Access Compliance Report

Public Rights-of-Way

(Curb Ramps)

Intersection ID: 49929	Main Street: ASHBOURNE_HALL_RD	Cross Street: CHAMBERLIN_RD	Location: SE
ADA ID: 75D70F5FD0F1	Ramp Type: Perp	Initial Pass/Fail: Fail	Overall Compliance: No
Severity Score: 12.5			
Codes/Mitigation Info/Possible Solution		Field Measurements/Component Compliance

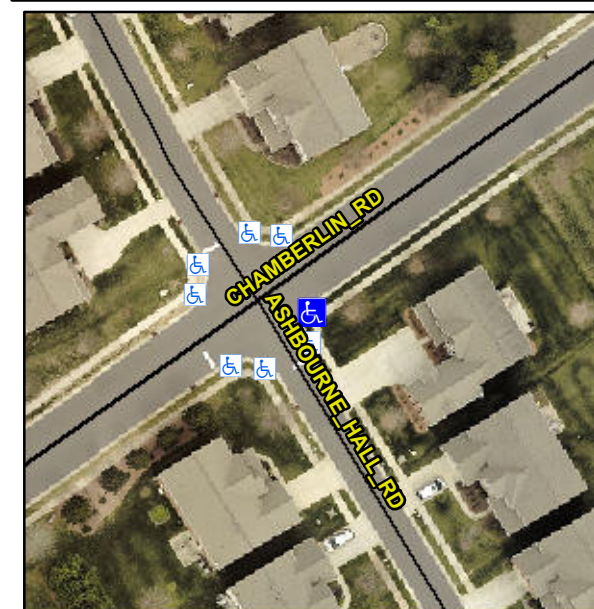
Not Found, R304.2.2

Compliance	Description	Data	Compliance	Description	Data
N/A	Ramp Length (in)	48.0	No	Ramp Slope (%)	10.9
Yes	Ramp Width (in)	48.0	Yes	Ramp XSlope (%)	0.4
N/A	Flare Type LT	N/A	N/A	Flare Type RT	N/A
N/A	Flare Slope LT (%)	N/A	N/A	Flare Slope RT (%)	N/A
N/A	Flare Traversable LT?	N/A	N/A	Flare Traversable RT?	N/A
N/A	Landing Length (in)	N/A	N/A	DWS Provided?	N/A
N/A	Landing Width (in)	N/A	N/A	DWS Contrast?	N/A
N/A	Landing Slope (%)	N/A	N/A	DWS Length (in)	N/A
N/A	Landing X Slope (%)	N/A	N/A	DWS Full Width?	N/A
N/A	Landing Curb? (Y/N)	N/A	N/A	DWS Offset (in)	N/A
N/A	Shared Landing?	N/A			
N/A	Gutter Ponding?	N/A	N/A	Gutter Slope (%)	N/A
N/A	Gutter Lip Ht (in)	N/A	N/A	Gutter X Slope (%)	N/A
N/A	Painted X Walk1?	No	N/A	Painted X Walk2?	N/A
	X Walk 1 Direction	To NW		X Walk 2 Direction	N/A
N/A	X Walk 1 Width (in)	N/A	N/A	X Walk 2 Width (in)	N/A
	X Walk 1 Slope (%)	4.0		X Walk 2 Slope (%)	N/A
	X Walk 1 X Slope (%)	2.7		X Walk 2 X Slope (%)	N/A

Remove & Replace Entire Ramp.
